January 25, 2024

A D D E N D U M N O. 3

Notice to All Persons and Firms Proposing
to Submit a Bid or Furnish Materials for
Bayless Avenue Bridge No. 419
St. Louis County Project No. AR-1686
Federal Project No. STP-4900(637)

BAYLESS AVENUE RESURFACING
ITS INTERCONNECT PLAN SHEET (1 OF 2)

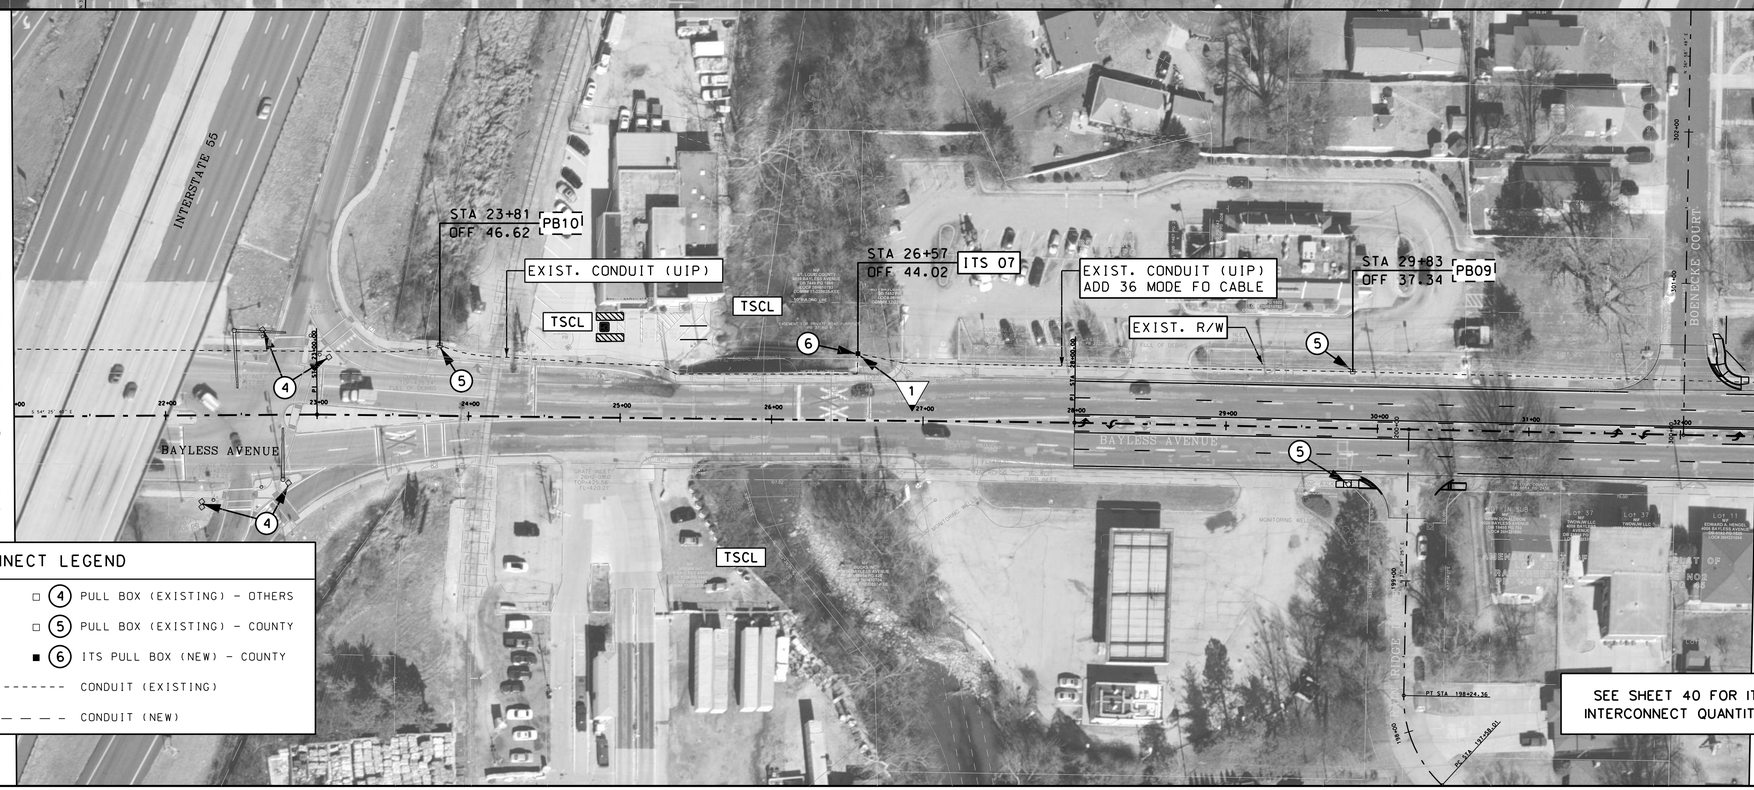
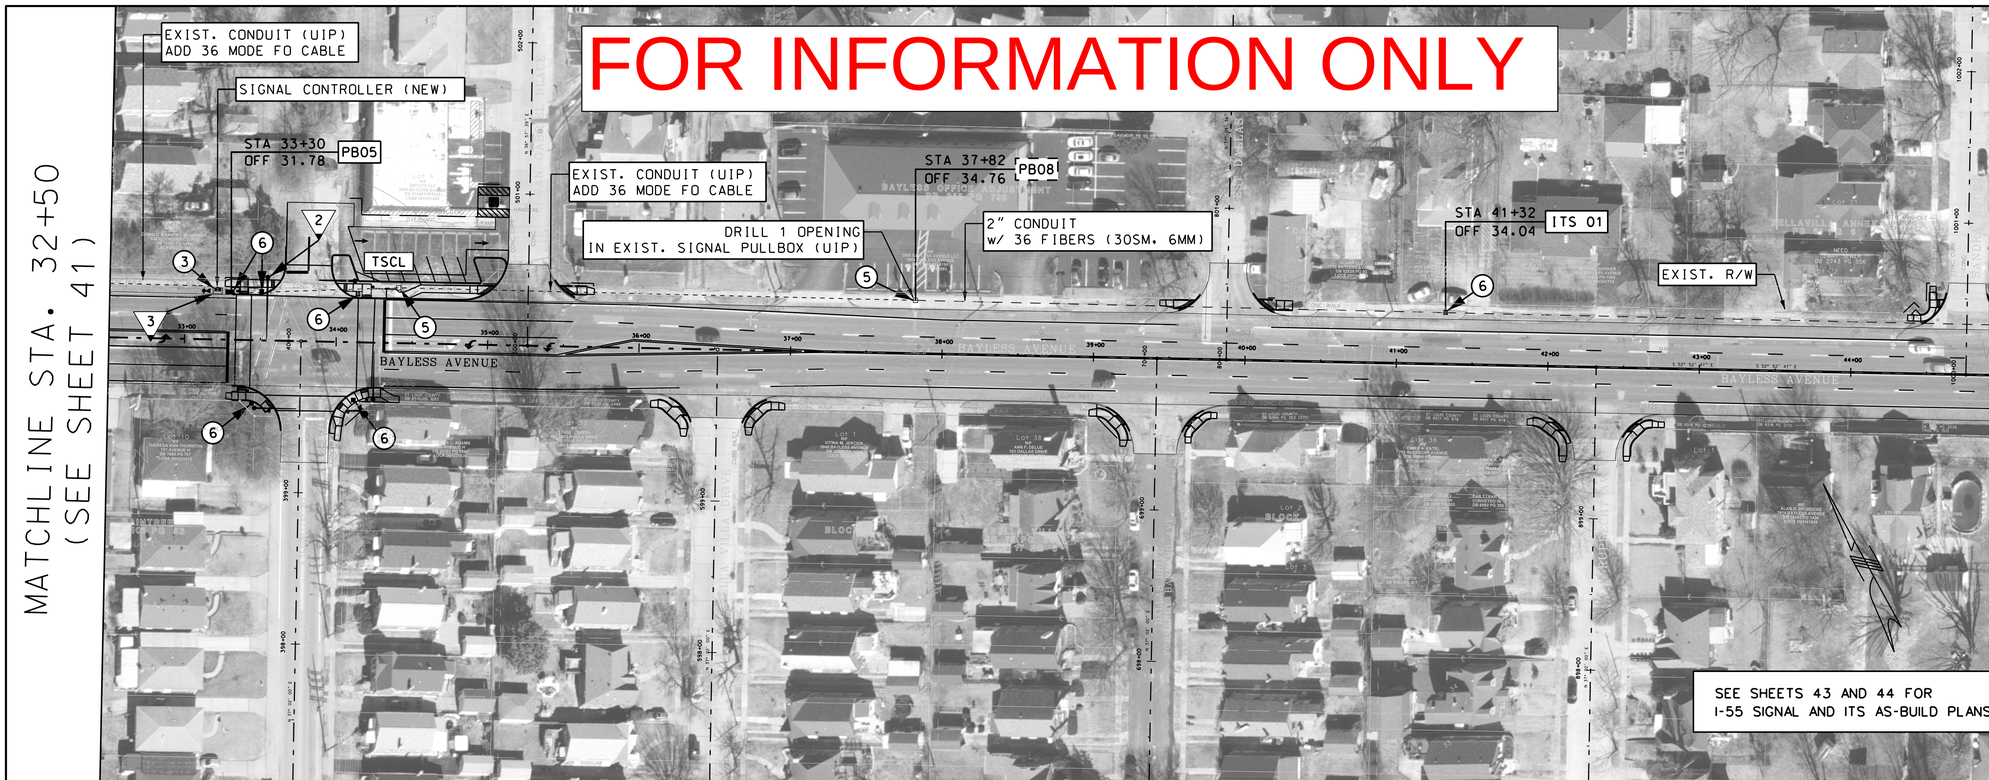
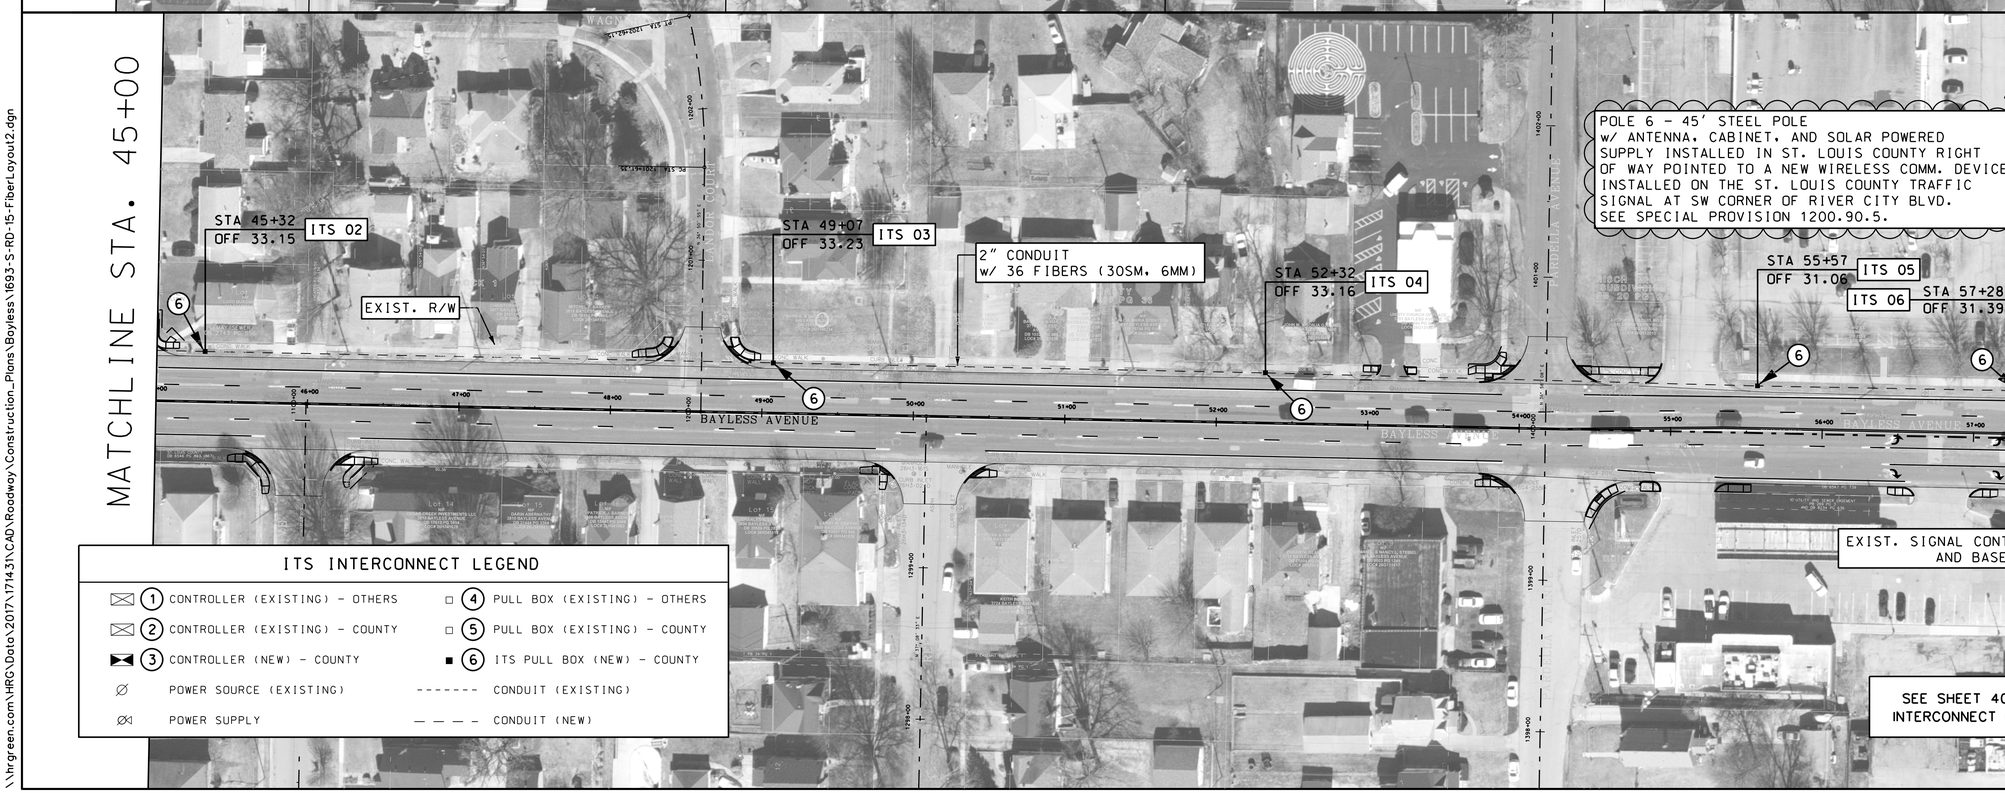
On Sheet 8, Note 5 what is currently in the traffic signal conduit on the bridge and if occupied does connection need to be maintained during bridge removal/construction?

The conduit on the bridge can be removed as noted on the plans. There is approximately 600' of fiber optic cable currently coiled in a pullbox from the Bayless Avenue Resurfacing Project at approximately Sta. 26+70 that was completed in 2023-see attached plan sheets from said project for reference. Once the new conduit on the bridge has been installed, Contractor will pull the fiber optic cable to the termination cabinet at I-55 and splice the fiber at this location. Bid Item No. 904-98.81 Relocation of Existing Interconnect Cable 600 L.F. and Bid Item No. 904-99.10 Fiber-Optic Fusion Splice, 48 Each have been added to the summary of quantities and the itemized bid sheet.
